Order No. EA-12-049

Clinton Power Station, Unit 1
Facility Operating License No. NPF-62
NRC Docket No. 50-461

Subject: First Six-Month Status Report in Response to March 12, 2012 Commission Order Modifying Licenses with Regard to Requirements for Mitigation Strategies for Beyond-Design-Basis External Events (Order Number EA-12-049)

**First Six-Month Status Report for the Implementation of Order EA-12-049, Order
Modifying Licenses with Regard to Requirements for Mitigation Strategies for Beyond-
Design-Basis External Events**

Figure 2
Suppression Pool Cooling and Low Pressure RPV Makeup from Suppression Pool
(Conceptual)

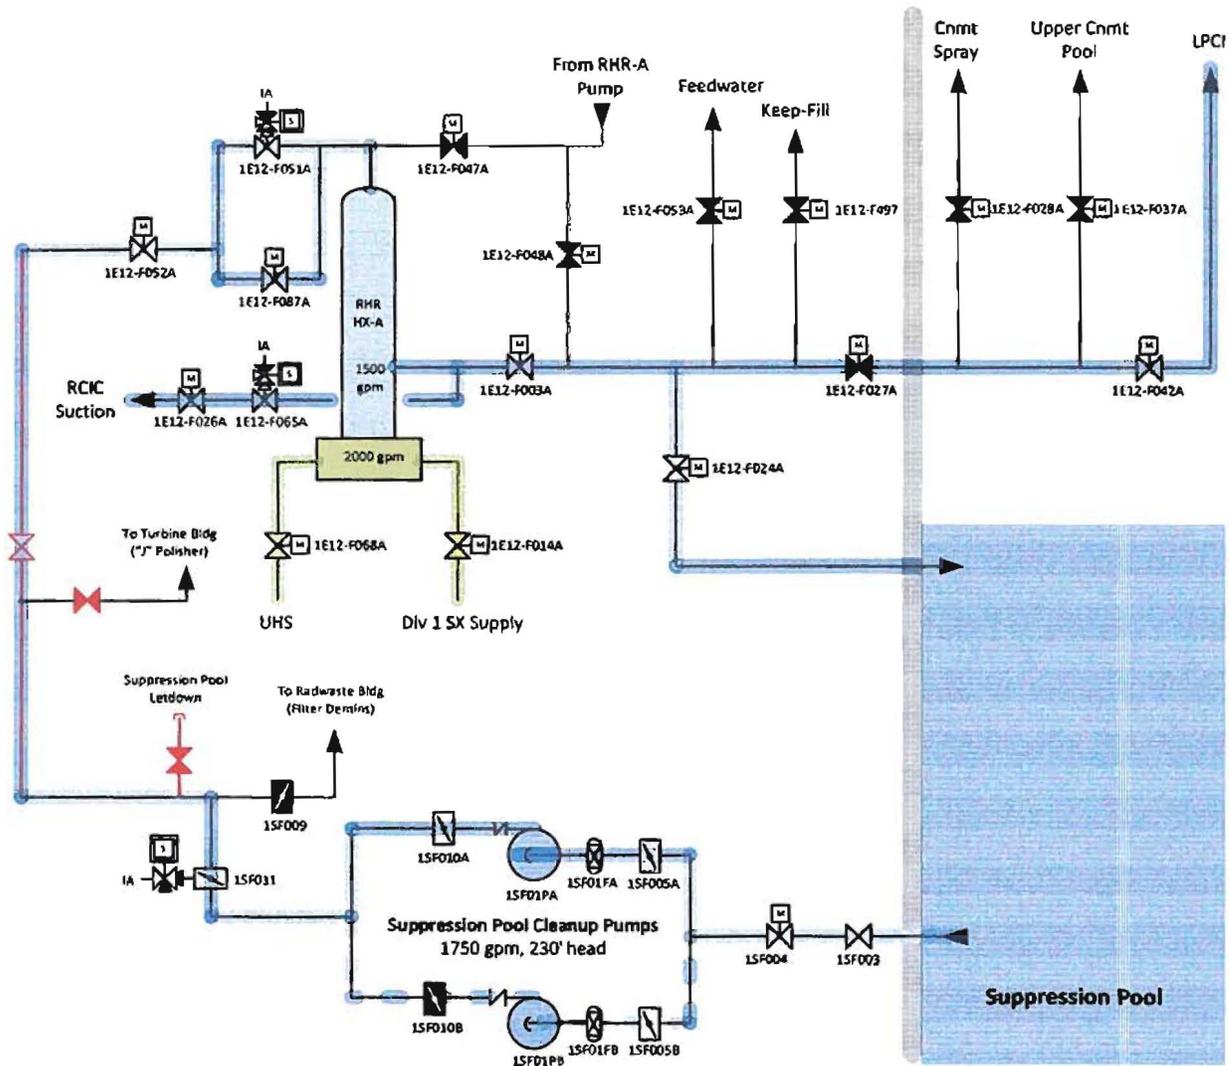
Reason for Change: This discussion is updated to include improvements in the conceptual design. First, the RCIC pump suction is shifted to a cooler water source at $t_0 + 8$ hours, and second, the primary source of water for low pressure RPV makeup is changed to the suppression pool (Figure 2). The UHS remains the alternate source of RPV makeup water (Figure 3).

Once the suppression pool lineup is completed, RCIC suction will be shifted to the RHR heat exchanger shell outlet using installed RHR steam condensing mode piping (Figure 1). This action limits the RCIC system exposure to elevated suppression pool temperature to the first eight hours of the event. The maximum water temperature the RCIC pump is exposed to is 200.7°F according to the MAAP analysis. Once the RCIC suction is shifted the RCIC suction water temperature is 138°F .

Figure 3
Low Pressure RPV Makeup from External Source
(Conceptual)

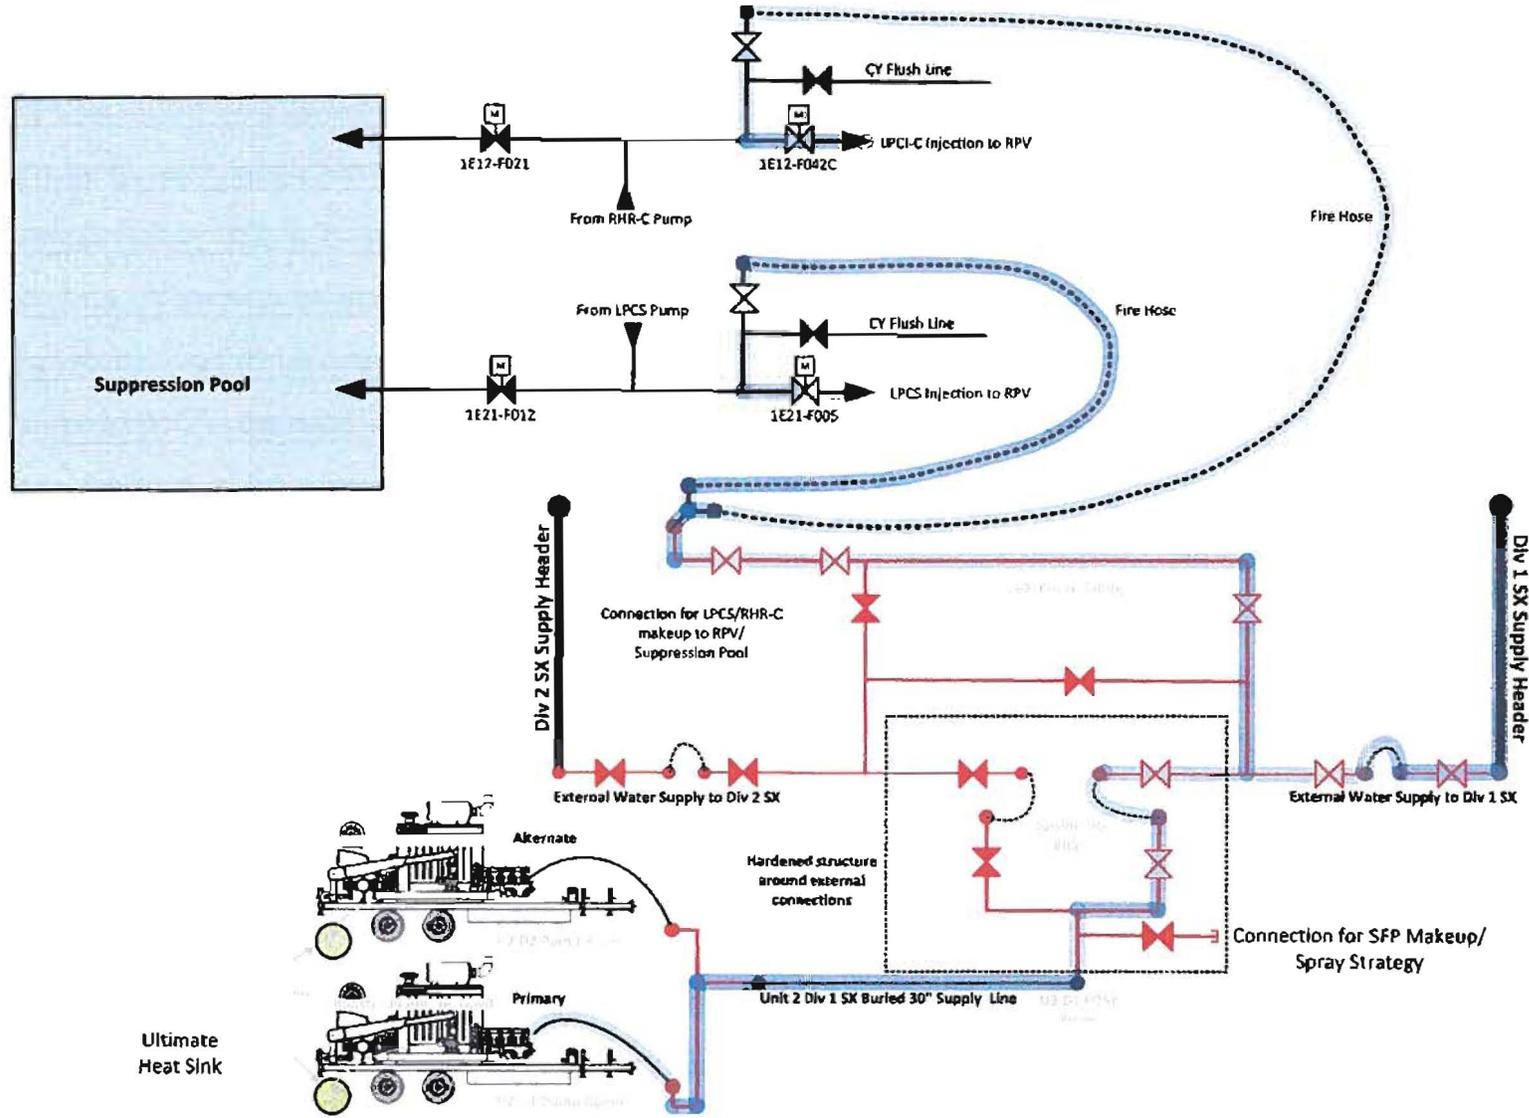
MCC 1A, and other needed AC loads. • Pre-routed cabling with cam-lock connectors	
Cooling/Makeup Water Support (Figure 3)		
The diesel driven pumps will be housed in a storage structure that meets NEI 12-06 Rev.0 storage requirements. A heavy duty truck capable of clearing debris will be stored in the same location.	Two external water connections.	FLEX piping, valves, and connections (electrical & fluid) will meet NEI 12-06 Rev.0 protection requirements.
The proposed means of routing the water from the UHS to the plant is via the unused seismically robust Unit 2 SX piping.	Connection to the Unit 2 SX supply piping from the UHS FLEX pump (proposed).

Figure 4
Electrical Strategy
(Conceptual)

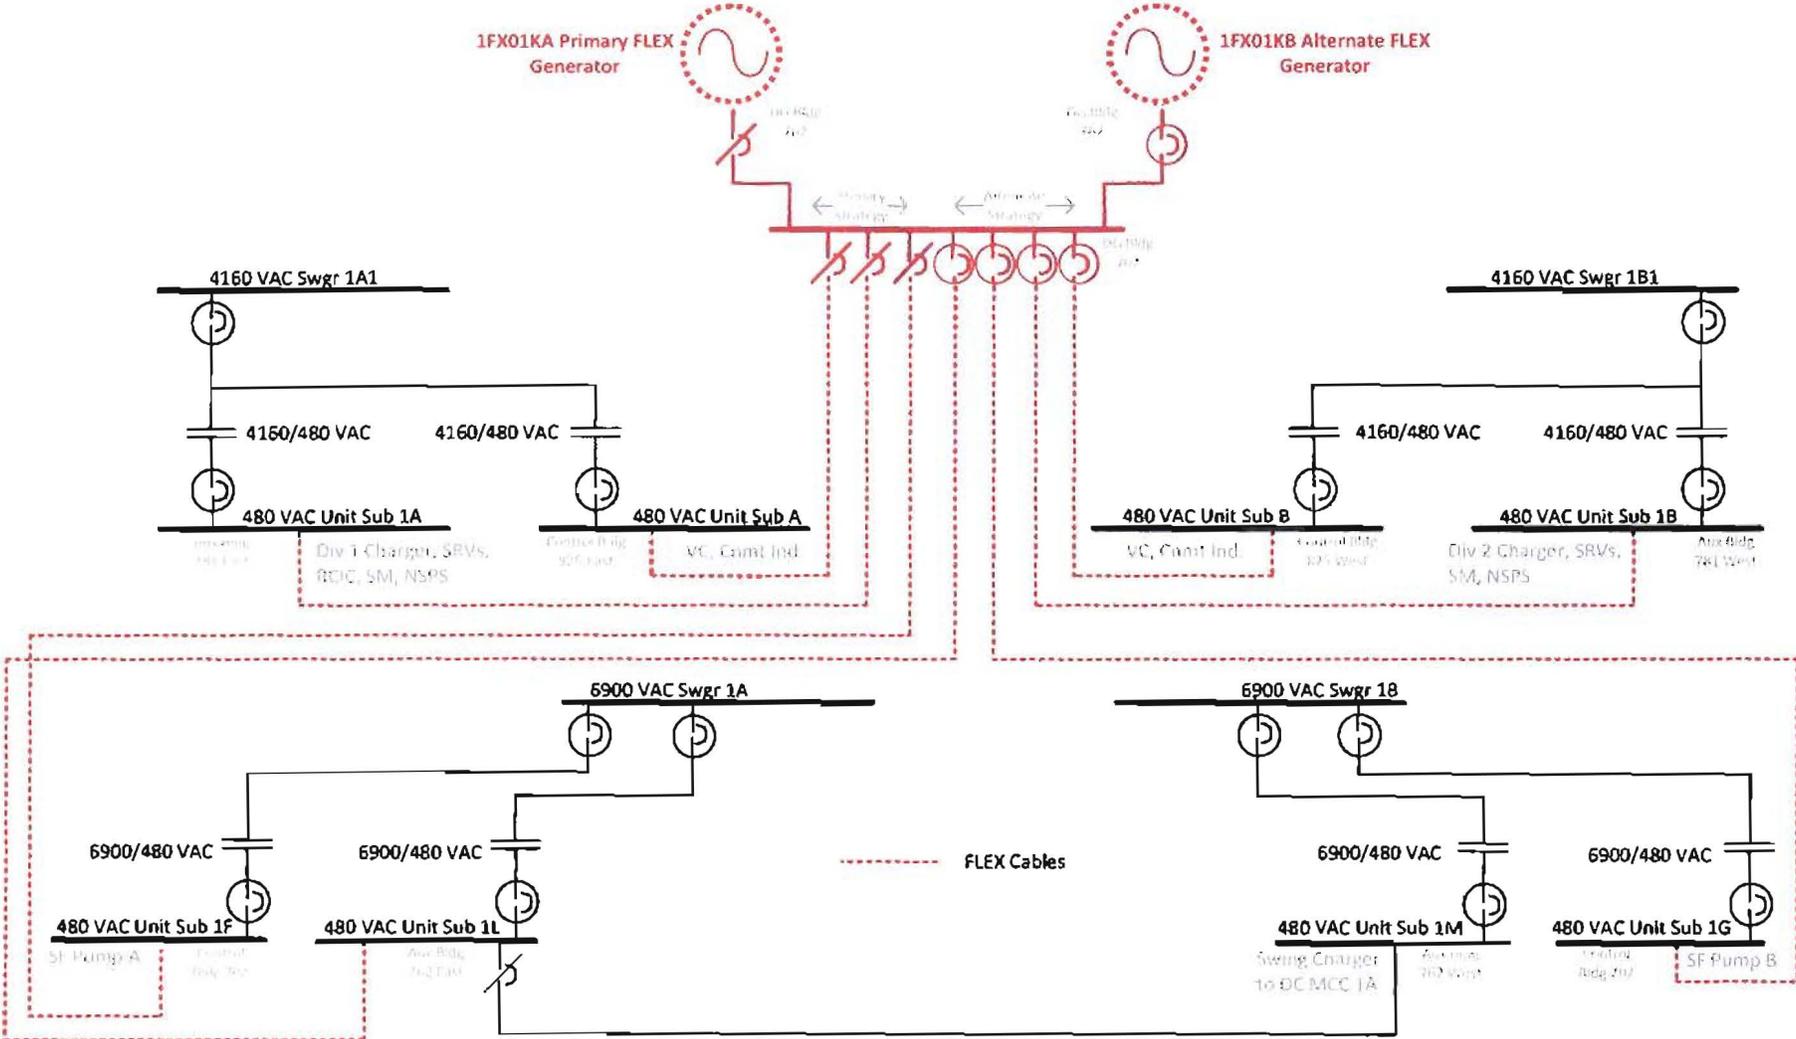
Key portions of the Division 1, Division 2, and non-divisional 480 VAC distribution system will be able to be re-energized from a pre-staged primary or alternate FLEX generator. Either generator independently will enable maintaining DC power for RCIC, SRV controls and vital instrumentation, and provide AC power for hydrogen Igniters, SPMU valves and Suppression Pool Cleanup and Transfer pumps (Figure 4).

Figure 7
FLEX Deployment Conceptual Sketch

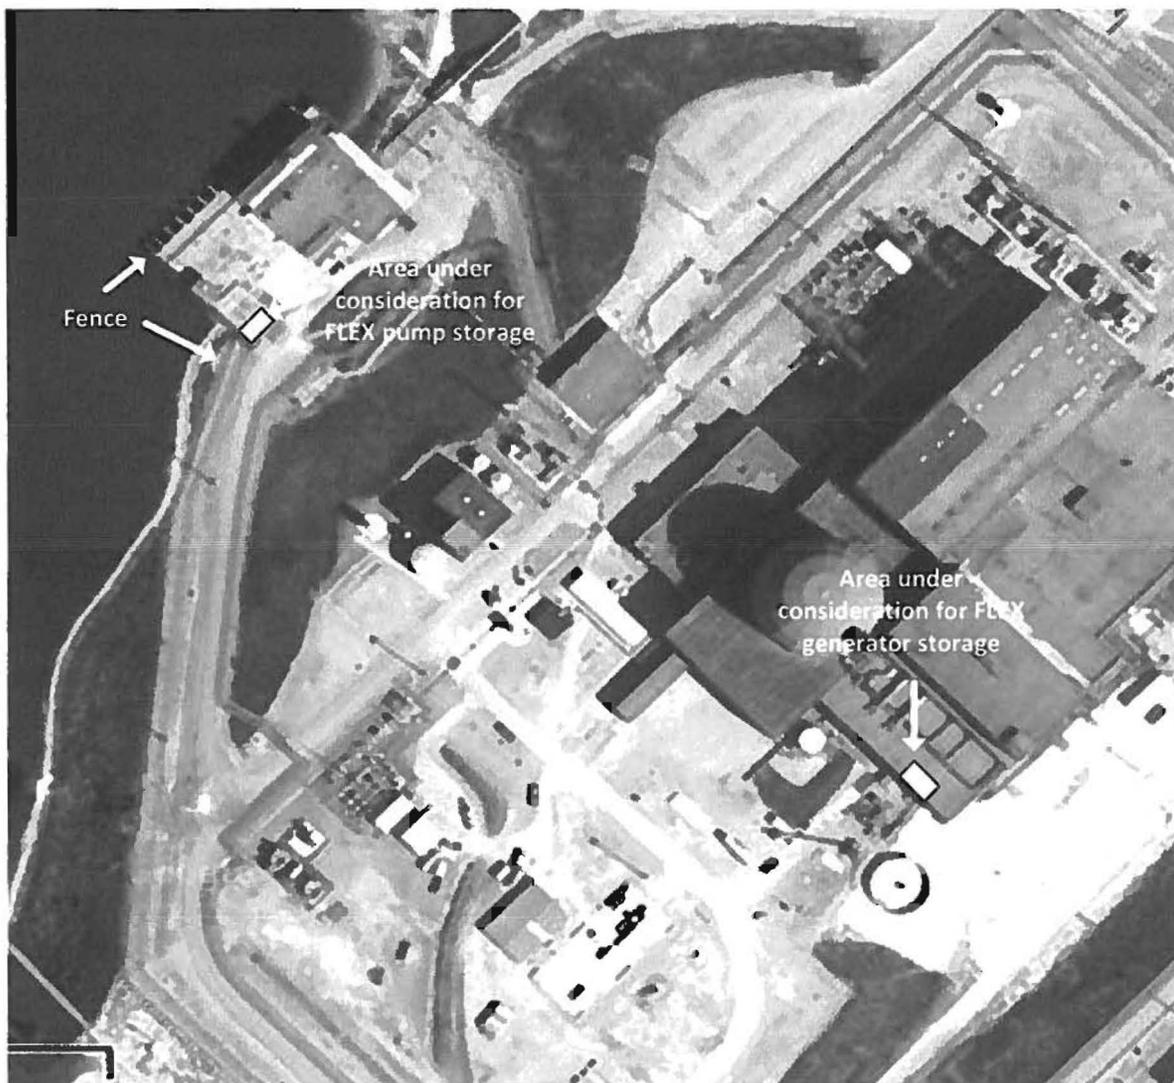
Deployment Conceptual Design		
(Figures 7 and 8 contain deployment conceptual sketches)		
Strategy	Modifications	Protection of connections
<i>Identify Strategy including how the equipment will be deployed to the point of use.</i>	<i>Identify modifications</i>	<i>Identify how the connection is protected</i>
The electrical support and cooling/makeup water support deployment strategies are common to core cooling, containment, and spent	The electrical support and cooling/makeup water support modifications are common to core cooling, containment, and spent fuel pool makeup functions. The discussion is in the Safety	The external connection points are common to core cooling, containment, and spent fuel pool makeup functions. The protection discussion is in the Safety Function Support section.

Deployment Conceptual Design		
(Figures 7 and 8 contain deployment conceptual sketches)		
Strategy	Modifications	Protection of connections
<i>Identify Strategy including how the equipment will be deployed to the point of use.</i>	<i>Identify modifications</i>	<i>Identify how the connection is protected</i>
Electrical Support (Figure 4)		
<p><i>The primary and alternate FLEX generator will be permanently staged and do not require deployment.</i></p> <p><i>Pre-staged cabling will be deployed from the FLEX generator to the Unit Substations that supply the components needed to meet the FLEX timeline.</i></p>	<ul style="list-style-type: none"> • <i>A permanently staged primary and alternate 480 VAC generator able to supply necessary portions of the 480 VAC distribution system to repower the Division 1 battery charger and other needed AC loads.</i> • <i>An external electrical connection able to supply 480 VAC power to switchgear inside the Control/DG building. The switchgear will be able to supply necessary portions of the 480 VAC distribution system to repower the Division 1 battery charger or the swing battery charger to supply DC</i> 	<p>FLEX piping, valves, and connections (electrical & fluid) will meet NEI 12-06 Rev.0 protection requirements.</p>
